**Amended [2]
ACR South Africa
TELLUSART MKII
FCC Part 80.1101
Compliance Report**

Re: **FCC ID 05HNAT-SARTII**

Re: **FCC ID B66ACR-SART-3**

TEST PROCEDURE
**Part 80 compliance
SART**

SPECTRAL PLOT OF SART BANDWIDTH.

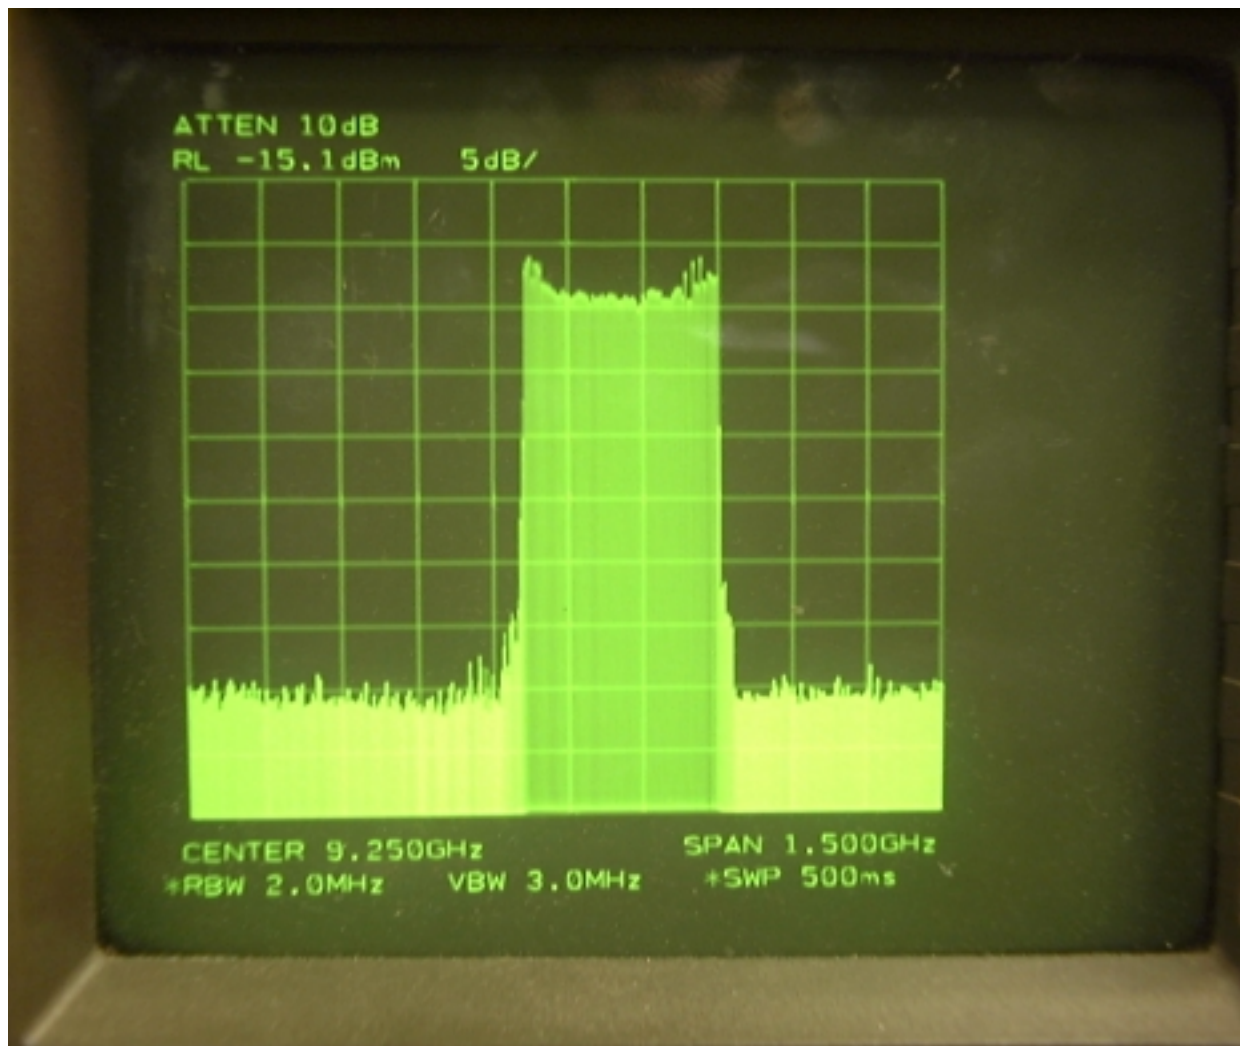
1. No bandwidth data - please provide
2. Provide details regarding how the output power was measured and state units.
3. Please provide letter requesting confidentiality as requested in section 0.459 of the rules.
Note that items such as photos and test report cannot be kept confidential
4. Cannot verify fee - please clarify or contact Bette Taube (btaub@fcc.gov) for assistance with fee payment

Bandwidth Data: occupied bandwidth was measured and the results are in Test report1.pdf, none of the examples and methods in this chapter paragraph apply. See spectral plot below of bandwidth.

- 1.) The SART by specification sweeps constantly over the band of 9.2 GHz (+0/-60MHz) to 9.5 GHz (+60/-0MHz) every time the transponder is interrogated. The performance of this sweep is verified over the temperature range -20 to + 55 degrees.

- 2.) SPECTRAL PLOT OF BANDWIDTH
